**Report: ISSUES**  
**Function: Test, Adjust, & Balance**  
**Date: 11/27/2023**

**PROJECT**  
**11-27-23 CULVERS-DELANO, MN**

## Issue List

**Incorrect**  
**11/27/2023**

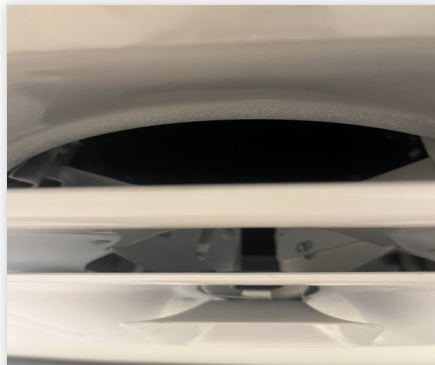
**Issue Name :** PRV-1 (RR Exhaust) Incorrect Grilles Installed  
**Description :** Installed Exhaust grilles in bathroom are supply grilles (SD-4). Plans call for EG-1 return grilles with OBD face damper. Installed grilles do not have have face damper and cannot be balanced. Recommend correct grilles are installed.
